FOUNDATION PLAN
BARN RELOCATION

389 E HEMENWAY LANE - EDGERTON, WI 53534

S001

1/S001 FOUNDATION PLAN
1/4"=1'-0"

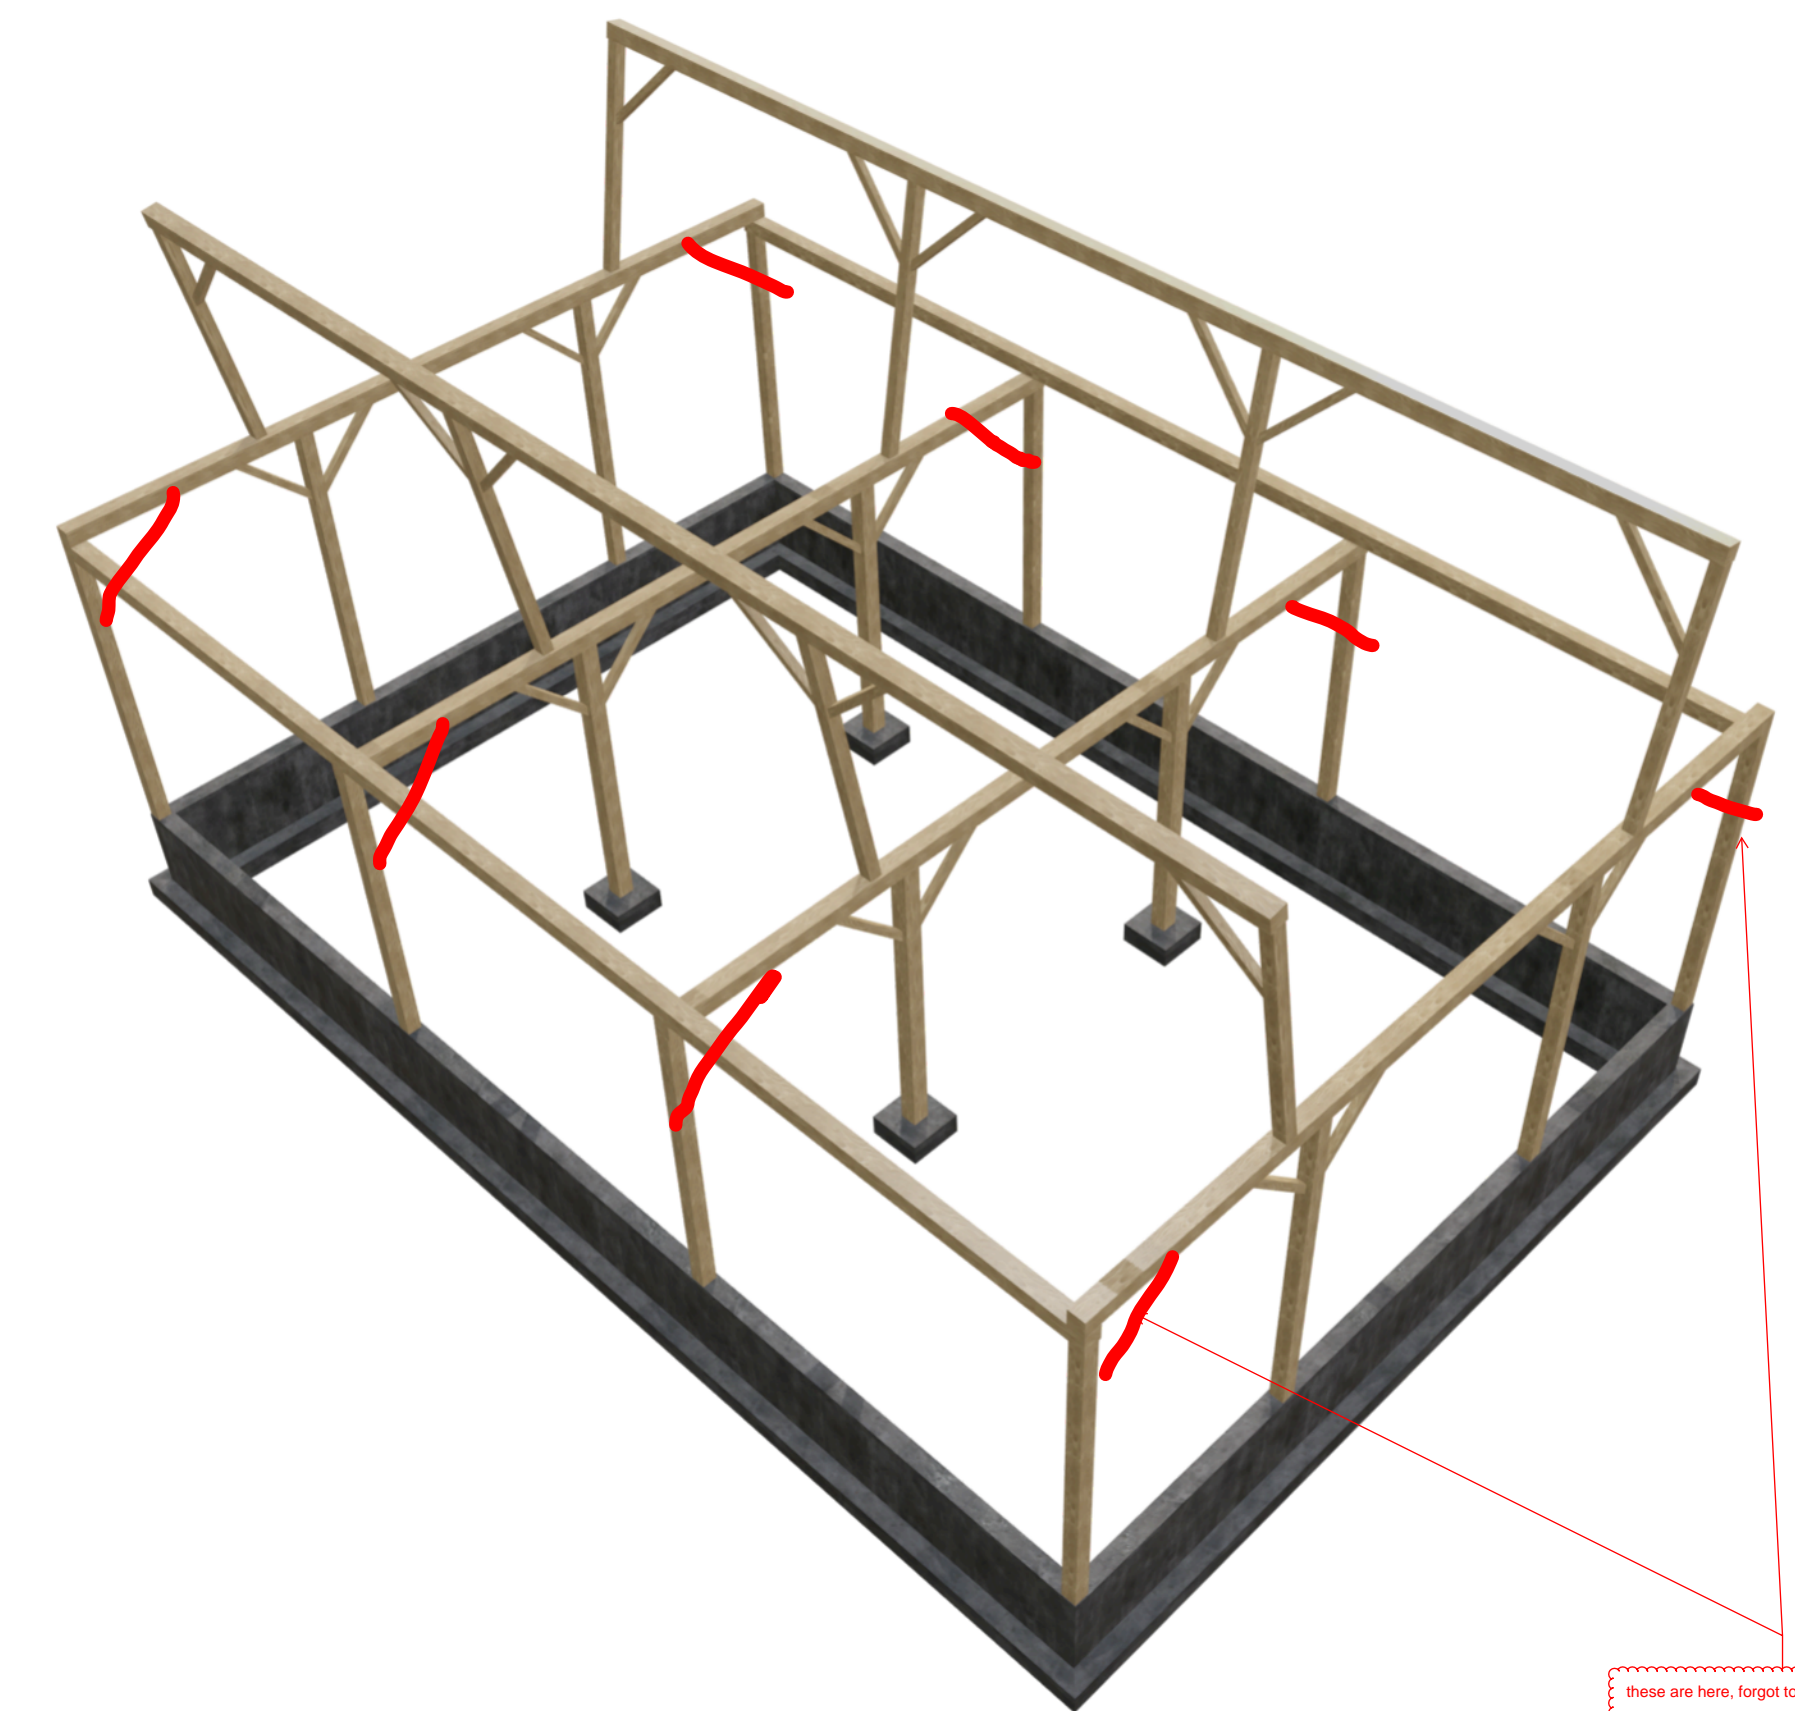
RYAN - DO YOU THINK WE SHOULD ADD STOOP WALLS AND FOOTINGS AT THE EXTERIOR DOORS?

LET ME KNOW WHAT THEY POURED. IF THE WALL FOOTING WIDTH IS +/- 20" WE WOULD NOT NEED TO CUT IT OUT TO ADD SOME FOOTINGS AT THE POSTS.

footings currently buried... I have a question to the concrete sub to get specs on what they poured.
